Notification subject: ERRATA - PIC12(L)F1822/PIC16(L)F1823 Silicon Errata and Data Sheet Clarification
Silicon Die Revision Addition

Description of Change: Addition of silicon die revision A9.

PIC12(L)F1822/PIC16(L)F1823 Family Silicon Errata and Data Sheet Clarification

FIGURE 1: INSTRUCTION CYCLE DELAY CALCULATION EXAMPLE

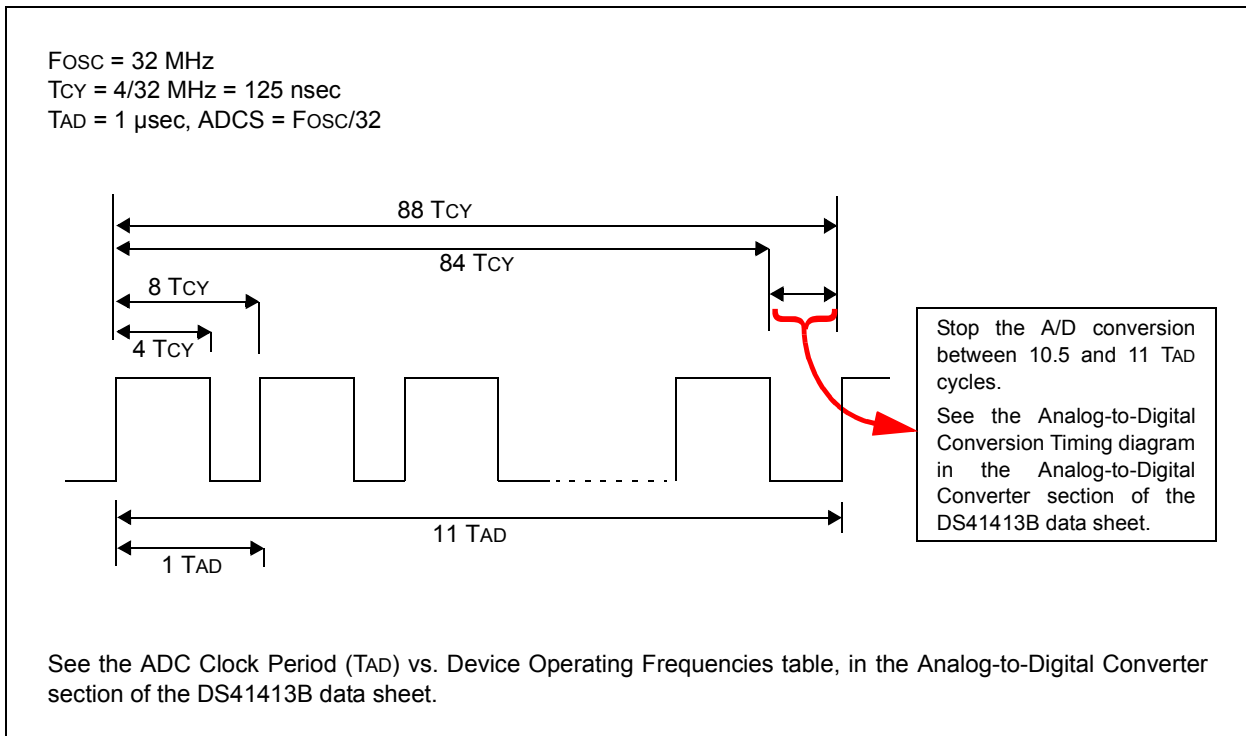
Under certain device operating conditions, the ADC conversion may not complete properly. When this occurs, the ADC Interrupt Flag (ADIF) does not get set, the GO/DONE bit does not get cleared and the conversion result does not get loaded into the ADRESH and ADRESL result registers.

Method 2: Provide a fixed delay in software to stop the A-to-D conversion manually, after all 10 bits are converted, but before the conversion would complete automatically. The conversion is stopped by clearing the GO/DONE bit in software. The GO/DONE bit must be cleared during the last 1/2 TAD cycle, before the conversion would have completed automatically. Refer to Figure 1 for details.

In Figure 1, 88 instruction cycles (TCY) will be required to complete the full conversion. Each TAD cycle consists of 8 TCY periods. A fixed delay is provided to stop the A/D conversion after 86 instruction cycles and terminate the conversion at the correct time as shown in the figure above.

Note: The exact delay time will depend on the choice of FOSC and the TAD divisor (ADCS) selection. The TCY counts shown in the timing diagram above apply to this example only. Refer to Table 3 for the required delay counts for other configurations.
